June 2016
FL702A-G
NHTSA #16V-121

Subject: FCCC XCP Chassis Power Steering Hoses

Models Affected: Specific Freightliner Custom Chassis XCP chassis manufactured April 26, 2013, through January 17, 2015.

Fig. 1, Steering Pump, Cummins ISX12

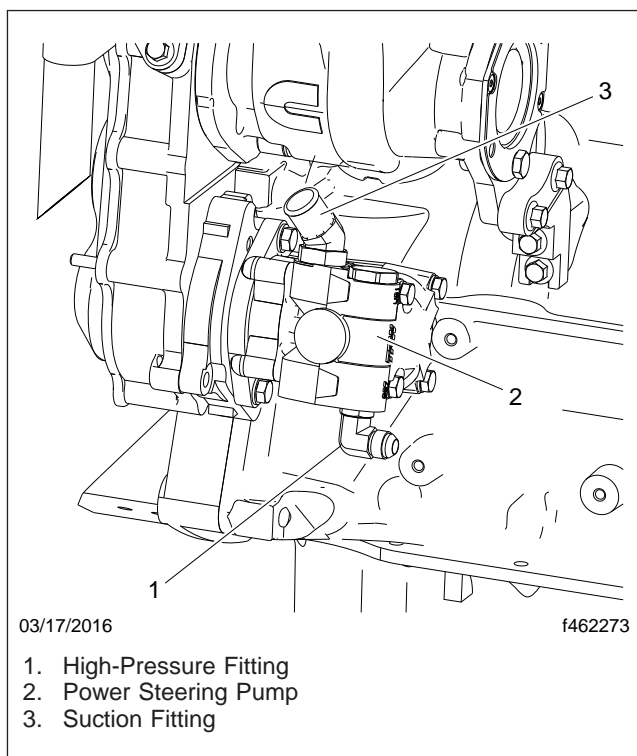
20. Remove the fittings from the power steering pump. Keep the supply (suction) fitting for the new power steering pump. Discard the high-pressure fitting and the power steering pump.
21. Remove and discard the power steering pump gasket from the mounting flange on the engine.
22. Install a new gasket on the mounting flange.
23. Install the fittings on the new power steering pump. Use the supply (suction) fitting removed earlier and tighten it 67 to 74 lbf-ft (91 to 100 N-m). Use a new high-pressure fitting and tighten it 33 to 36 lbf-ft (45 to 49 N-m).
24. Using the mounting bolts, install the power steering pump. Tighten the mounting bolts 25 lbf-ft (34 N-m). See [Fig. 1](#) and [Fig. 2](#).
